APP/16/00921 - Dolphin Quay, Queen Street, Emsworth

I write further to the appearance of drawing 18-3130-126-P8 on the Council's planning website in relation to flood defence. This drawing by Hamill Davies Ltd has been amended to show brick cladding to the concrete upper section of the sea defence wall. The construction shown is deficient as per the annotations below:

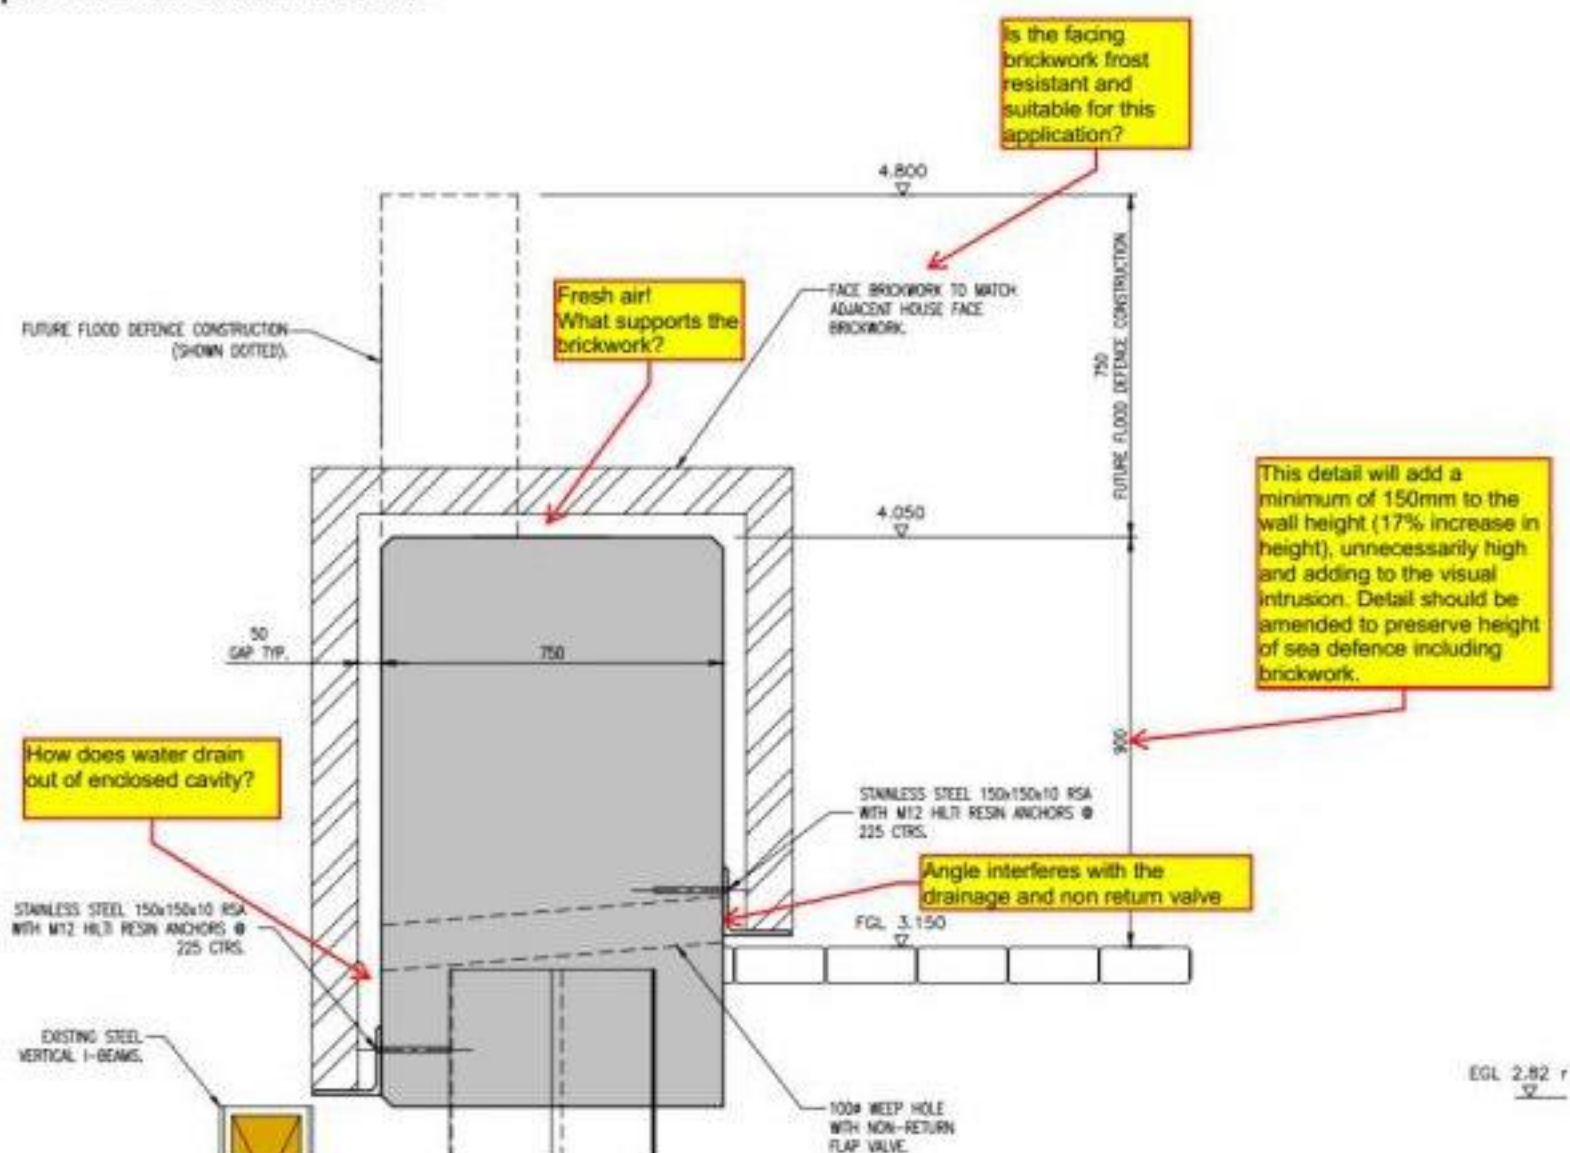
Drawings submitted in connection with the discharge of conditions should be technically credible.
